Access Compliance Report

Public Rights-of-Way

(Curb Ramps)

Intersection ID: 49557	Main Street: STEEL_YARD_CT	Cross Street: WARREN_BURGESS_LN	Location: W
ADA ID: 6B81A8EC4E30	Ramp Type: Perp	Initial Pass/Fail: Fail	Overall Compliance: No
Severity Score: 13.75			
Codes/Mitigation Info/Possible Solution		Field Measurements/Component Compliance

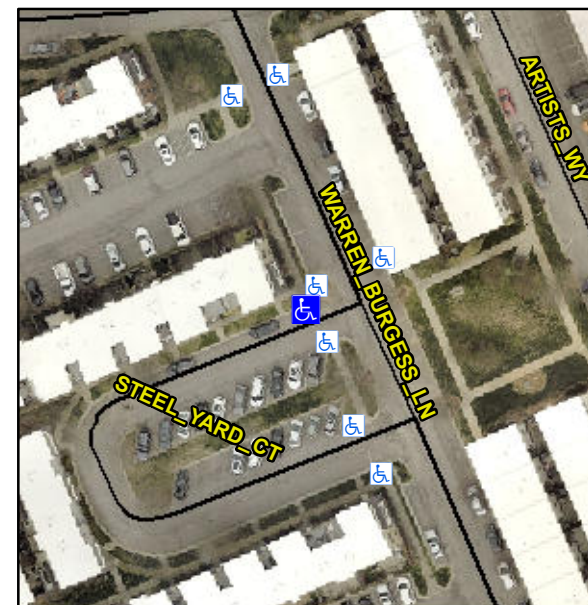
Not Found, R304.2.2, R304.5.3

Compliance	Description	Data	Compliance	Description	Data
N/A	Ramp Length (in)	72.0	No	Ramp Slope (%)	11.5
Yes	Ramp Width (in)	48.0	No	Ramp XSlope (%)	3.2
N/A	Flare Type LT	N/A	N/A	Flare Type RT	N/A
N/A	Flare Slope LT (%)	N/A	N/A	Flare Slope RT (%)	N/A
N/A	Flare Traversable LT?	N/A	N/A	Flare Traversable RT?	N/A
N/A	Landing Length (in)	N/A	N/A	DWS Provided?	N/A
N/A	Landing Width (in)	N/A	N/A	DWS Contrast?	N/A
N/A	Landing Slope (%)	N/A	N/A	DWS Length (in)	N/A
N/A	Landing X Slope (%)	N/A	N/A	DWS Full Width?	N/A
N/A	Landing Curb? (Y/N)	N/A	N/A	DWS Offset (in)	N/A
N/A	Shared Landing?	N/A			
N/A	Gutter Ponding?	N/A	N/A	Gutter Slope (%)	N/A
N/A	Gutter Lip Ht (in)	N/A	N/A	Gutter X Slope (%)	N/A
N/A	Painted X Walk1?	Yes	N/A	Painted X Walk2?	N/A
	X Walk 1 Direction	To S		X Walk 2 Direction	N/A
N/A	X Walk 1 Width (in)	49.0	N/A	X Walk 2 Width (in)	N/A
	X Walk 1 Slope (%)	0.2		X Walk 2 Slope (%)	N/A
	X Walk 1 X Slope (%)	0.0		X Walk 2 X Slope (%)	N/A

Remove & Replace Entire Ramp.
